**HISTORIC PRESERVATION REVIEW BOARD
STAFF REPORT AND RECOMMENDATION**

Landmark/District: **Mount Pleasant Historic District** (x) Agenda
Address: **3212 19th Street NW**

Meeting Date: **May 25, 2023** (x) Alteration
Case Number: **23-329 and 23-330** (x) Permit

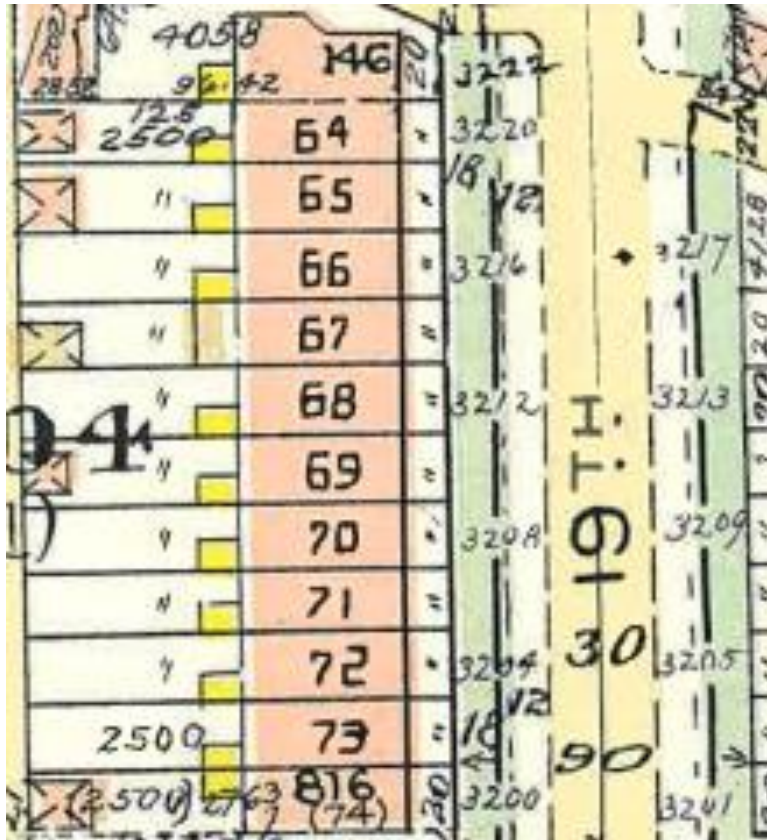
Based upon photos going back two decades, the original dormer windows were divided-light, with configurations appropriate to the shape of the openings. The sash in the rectangular openings with flat or hipped roofs was fifteen lights over one, as appear in Google Streetview photos of this property as recently as June 2019, more than a year after the property was purchased by the applicant. The applicant had obtained a permit for window replacements in September 2018, and it called for fifteen-over-one windows at the attic, as one would expect, but one-over-one windows were installed.¹

Concrete walks are monolithic and generally monochromatic, even if, upon close inspection, historic concrete is generally textured with a brownish pebble aggregate and sand that provides a warm tone. The particolored flagstone overlay here creates an especially striking contrast in its hues and bold mortar joints. The steps' cheek walls were also parged in a lighter color.²

While HPO cannot support the work as compatible with the character of the historic district or sufficiently retentive of (let alone enhancing) the character of the subject property, one possible compromise would be to leave the flagstones only on the porch deck, where they are less prominently visible.

HPO recommends that the Board not recommend approval of a permit for the dormer windows and the paving as is, but support the windows being replaced with compatible fifteen-over-one windows, and the stone being removed from at least the walk and steps.
